From: Jerry Clontz
Sent: Tuesday, September 23, 2014 2:31 PM
To: Andrew Zientara
Cc: Dan McCoy
Subject: RE: Trailers
Attachments: 20140923 M210248 Mark Up.pdf; 42210009.pdf

Driver just called CCT, they are about ½ hr from shop. I sent Scott the diagram to make the changes. Attached are the drawings you will need for #2015 (530945) coming to your shop next week

STRICK CORP.
TITLE/DESCRIPTION: BRAKE
BRAKE, WABCO,2S/1M,(BNKLY,CB40D,LSTOP, WABCO/SEALCO,[1]TANK,AUTO-POSLIF,POSLOK, AIR-PIN ASSIST
M210248
SHEET NO. 1 OF 1
M210248

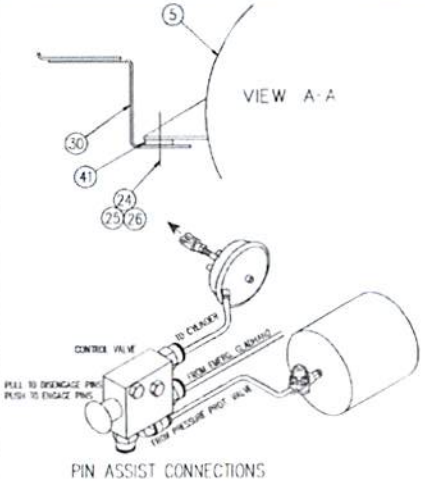
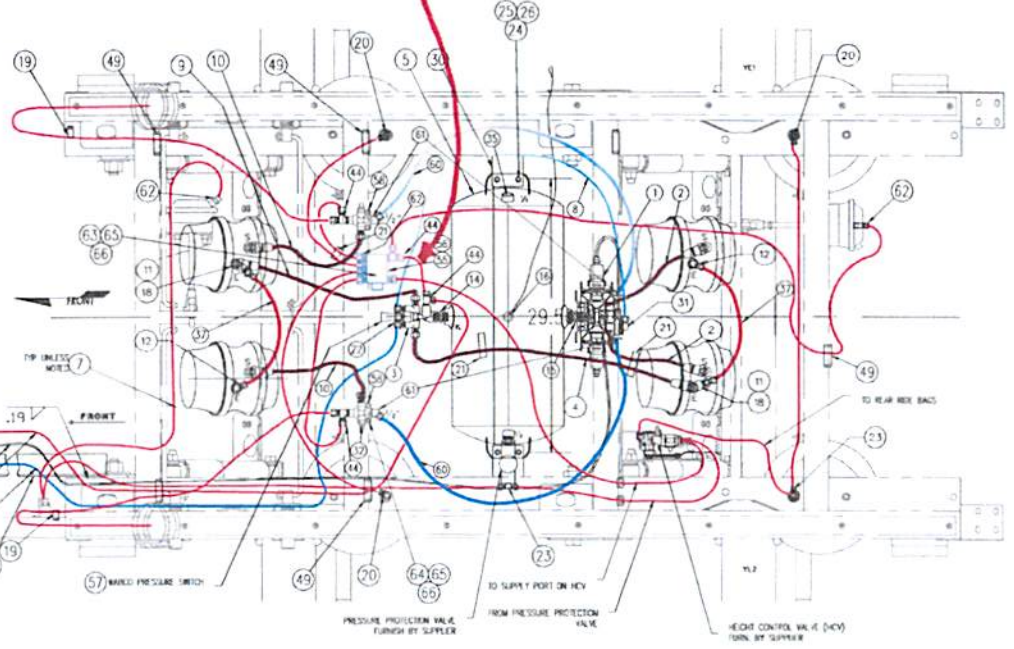
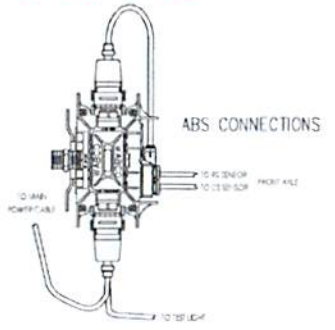
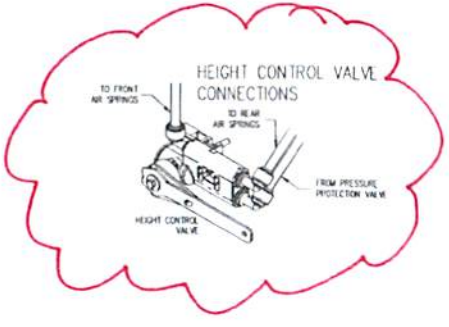
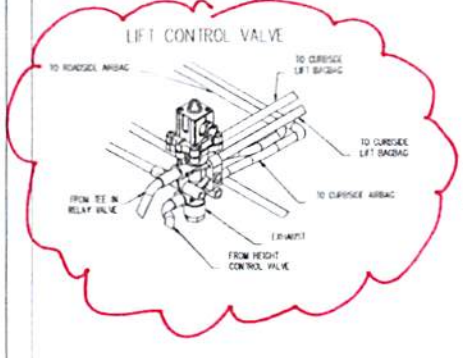
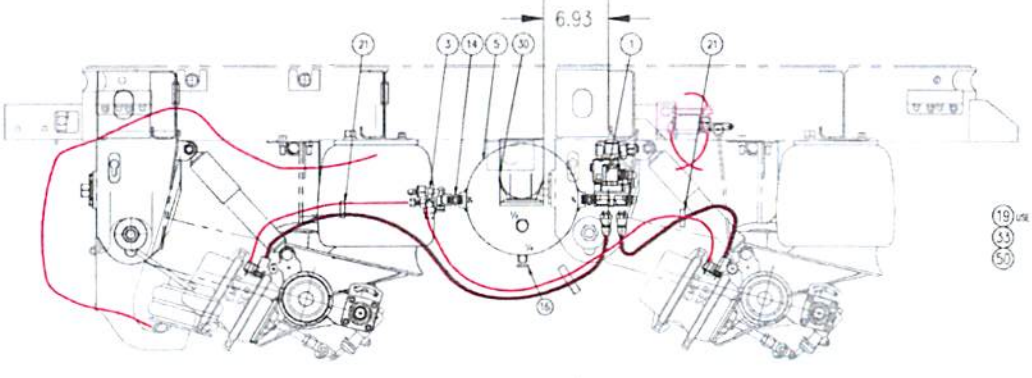
LINE FROM TEE IN RELAY VALVE
REMOVE THIS LINE.

TITLE/DESCRIPTION: BRAKE
BRAKE,WABCO,2S/1M,(UNLY),CB40D,ESTOP, WABCO/SEALCO,(1)TANK,AUTO-POSILIFT/POSLOK, AIR-PIN ASSIST

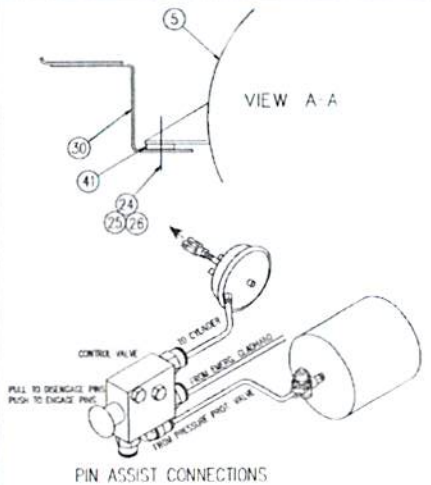
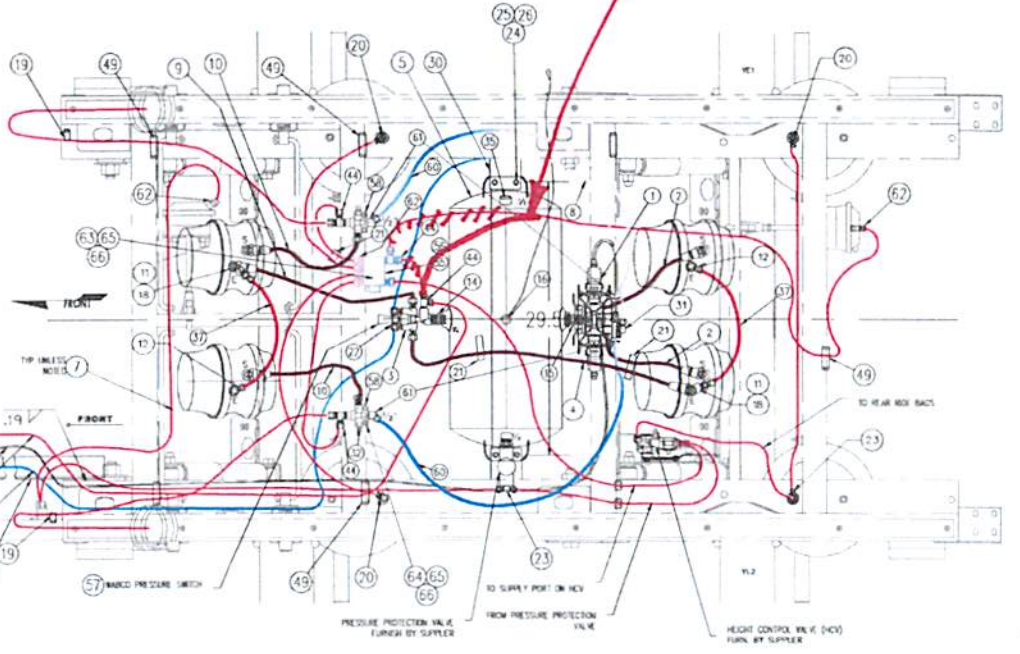
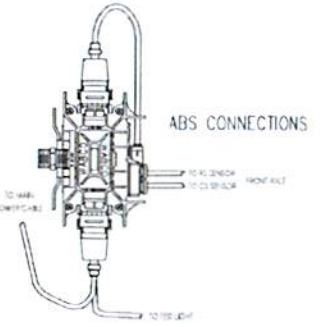
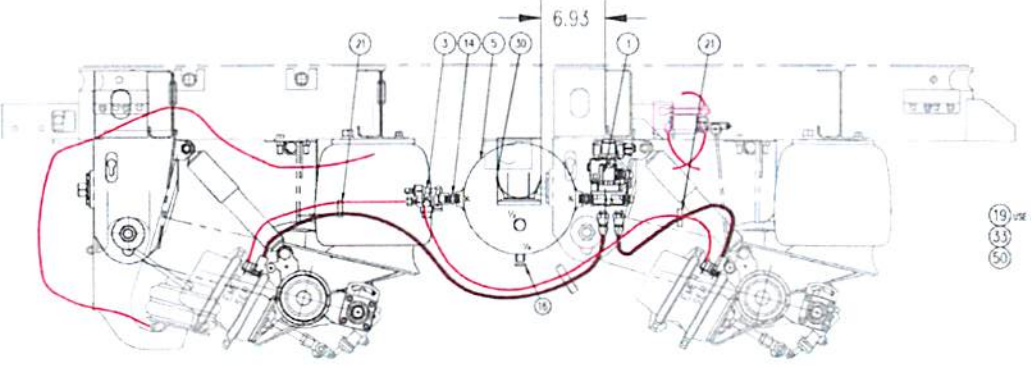
REROUTE LINE FROM POSILOCK CHAMBER TO OPEN PORT IN TEE AT RELAY VALVE.

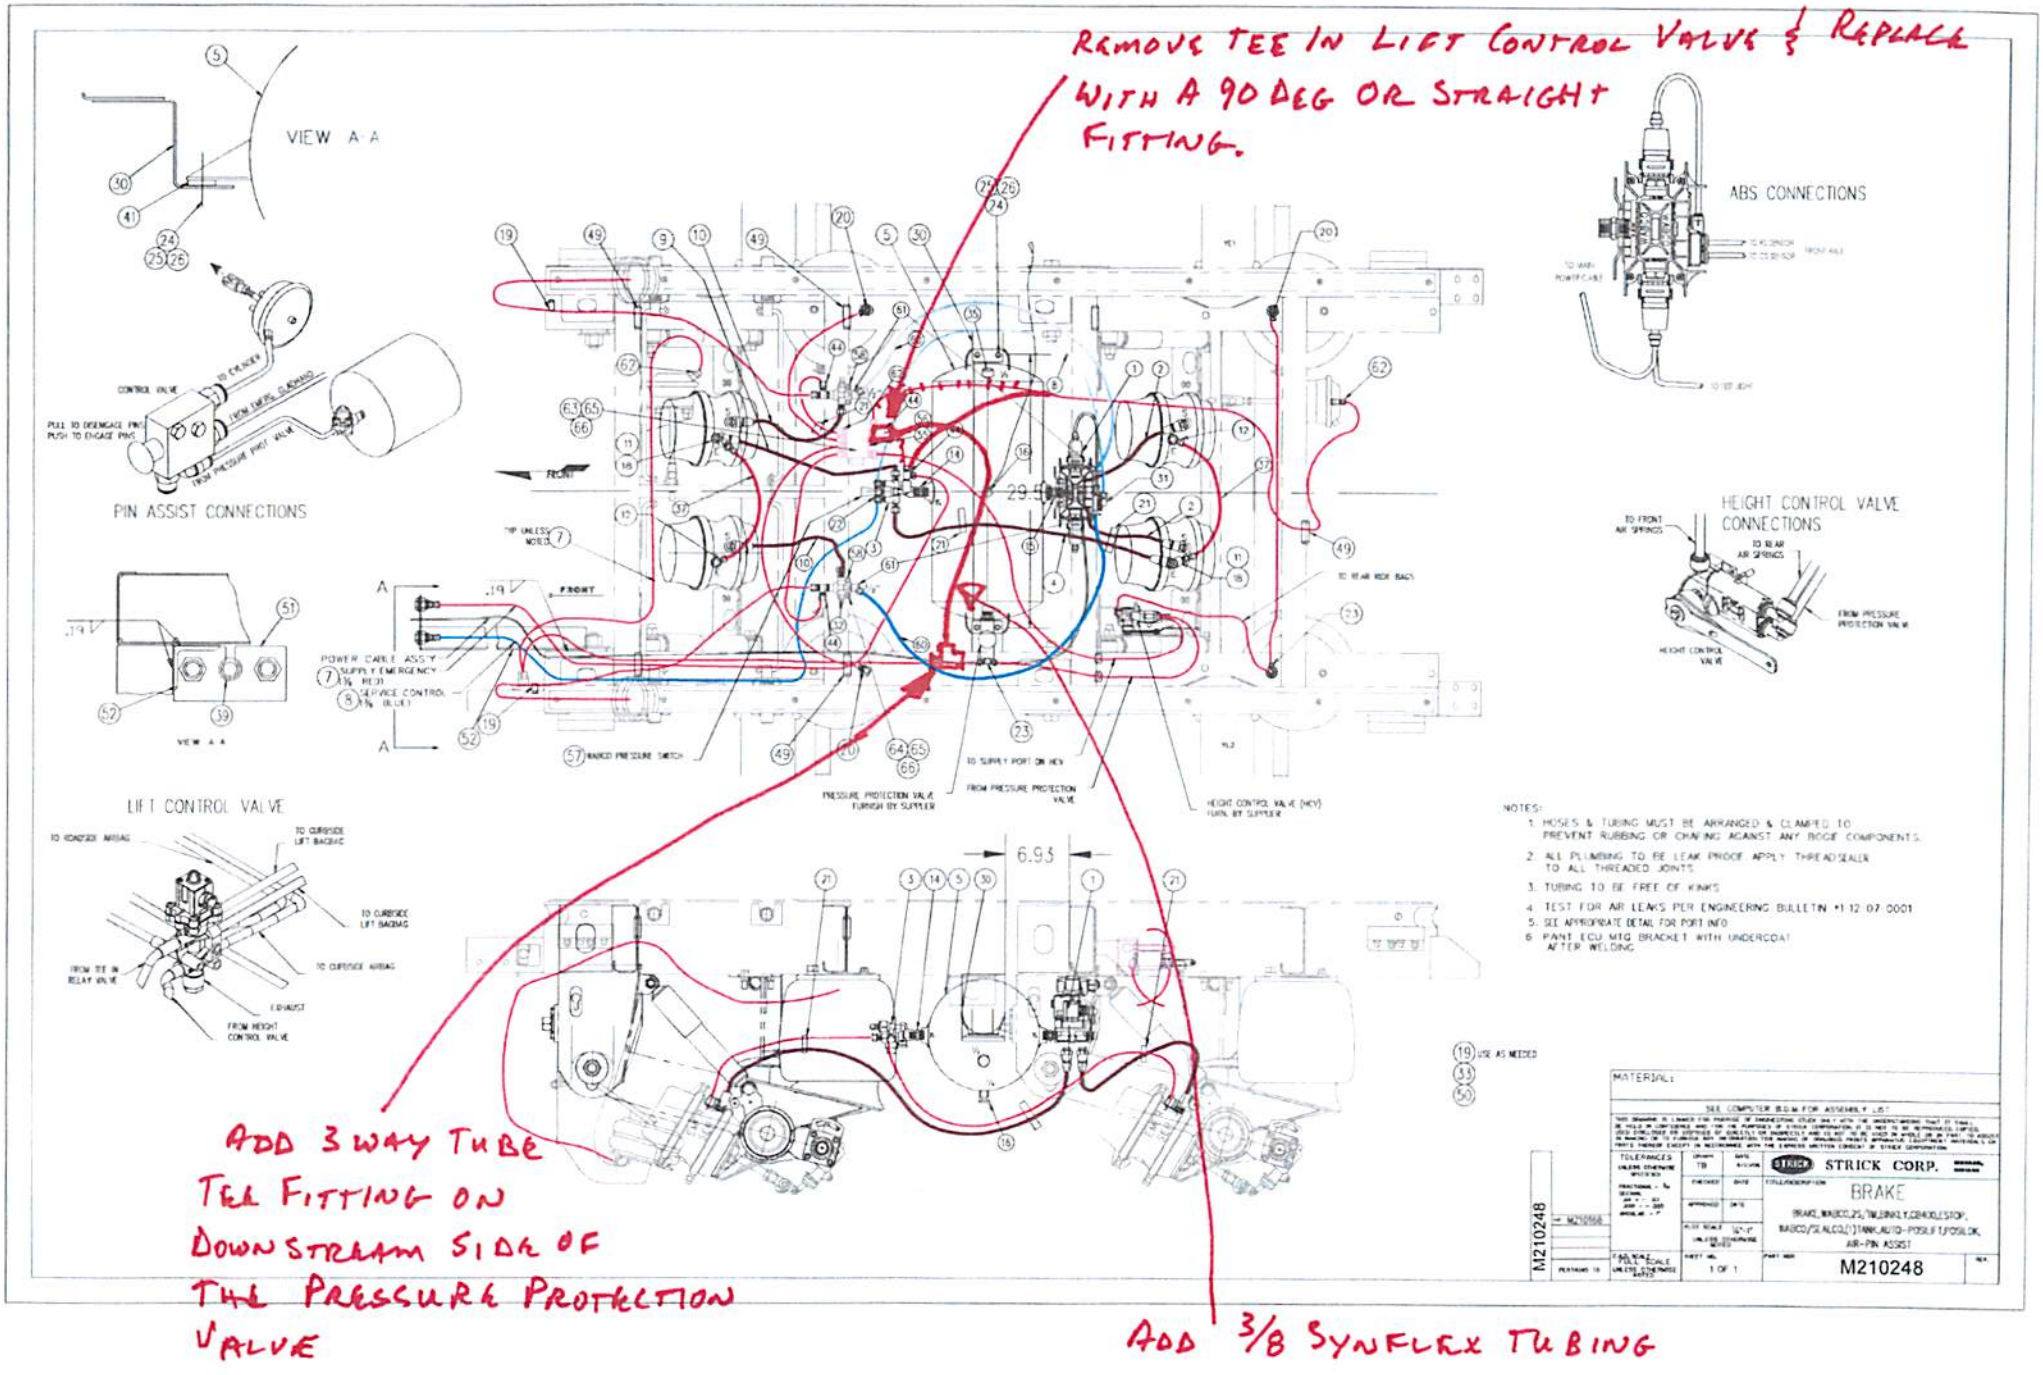
REMOVE TEE IN LIFT CONTROL VALVE & REPLACE WITH A 90 DEG OR STRAIGHT FITTING.
VIEW A-A
PIN ASSIST CONNECTIONS
ABS CONNECTIONS
HEIGHT CONTROL VALVE CONNECTIONS
LIFT CONTROL VALVE
FRONT
POWER CABLE ASSY
SUPPLY EMERGENCY
SERVICE CONTROL
NOTES:
1. HOSES & TUBING MUST BE ARRANGED & CLAMPED TO PREVENT RUBBING OR CHAFING AGAINST ANY BOGIE COMPONENTS.
2. ALL PLUMBING TO BE LEAK PROOF. APPLY THREADSEALER TO ALL THREADED JOINTS.
3. TUBING TO BE FREE OF KINKS.
4. TEST FOR AIR LEAKS PER ENGINEERING BULLETIN #1.12.07.0001
5. SEE APPROPRIATE DETAIL FOR PORT INFO.
6. PAINT ECU MTG BRACKET WITH UNDERCOAT AFTER WELDING.
ADD 3 WAY TUBE TEE FITTING ON DOWNSTREAM SIDE OF THE PRESSURE PROTECTION VALVE
ADD 3/8 SYNFLEX TUBING
STRICK CORP.
BRAKE
M210248
